UNITED STATES ENVIRONMENTAL PROTECTION AGENCY

**Re: Albion Sheridan Landfill Superfund Site
Notification of Disapproval of Preliminary Design**

Memorandum For Turpin Ballard, USEPA Region V**Subject:** Albion-Sheridan Township Landfill.

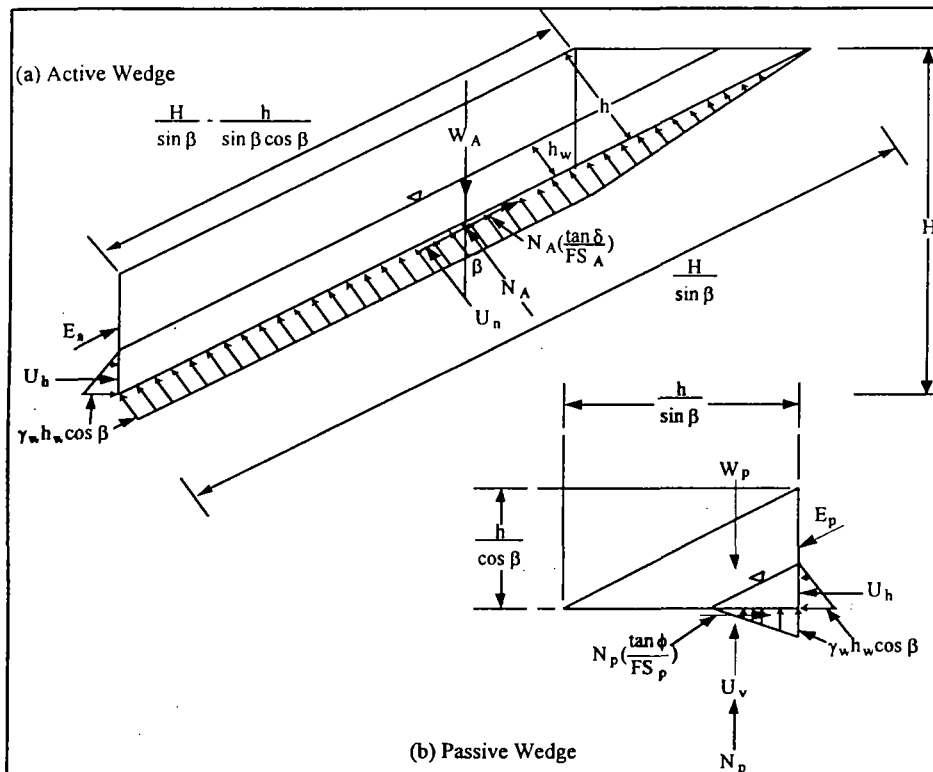
MARTELLO'S
HAND
CALC

ABOVE
Geotextile

CASE: B? Full Depth Flow, $\delta = 25^\circ$, NO TOE BUTTRESS

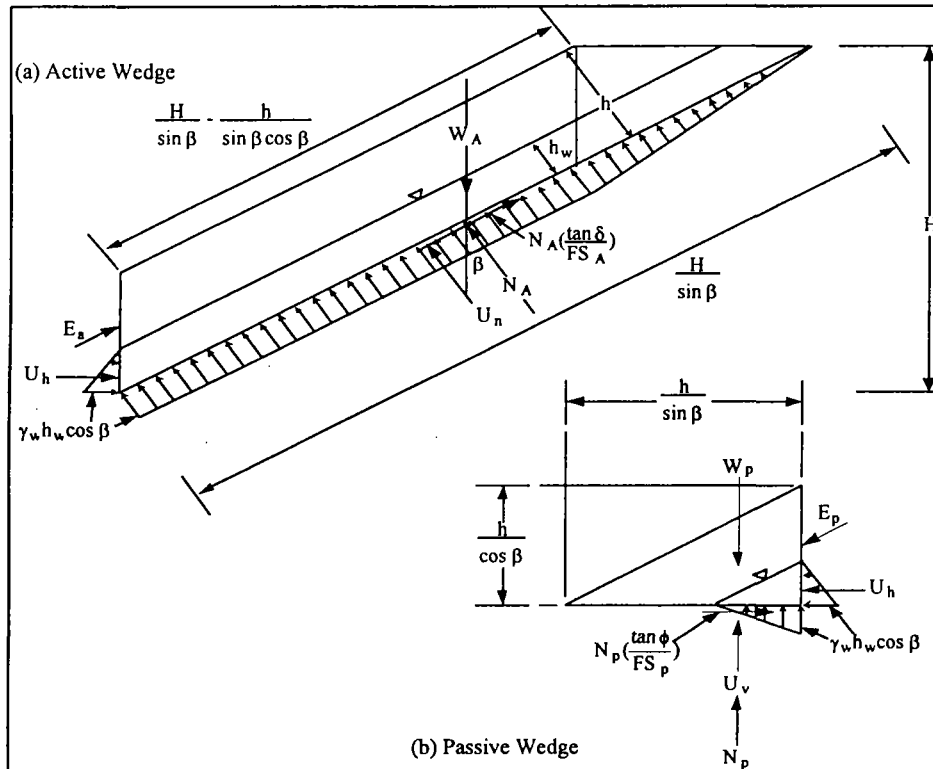
matches
Sheet 4
Case
A

thickness of cover soil = $h = 0.76 \text{ m}$
length of slope measured along the geomembrane = $L = 200.0 \text{ m}$
soil slope angle beneath the geomembrane = $\beta = 14.0^\circ$
vertical height of the slope measured from the toe = $H = 48.4 \text{ m}$
parallel submergence ratio = $PSR = 1.00$
depth of the water surface measured from the geomembrane = $hw = 0.76 \text{ m}$

Less Length
to mimic
infinite
slope
conditions
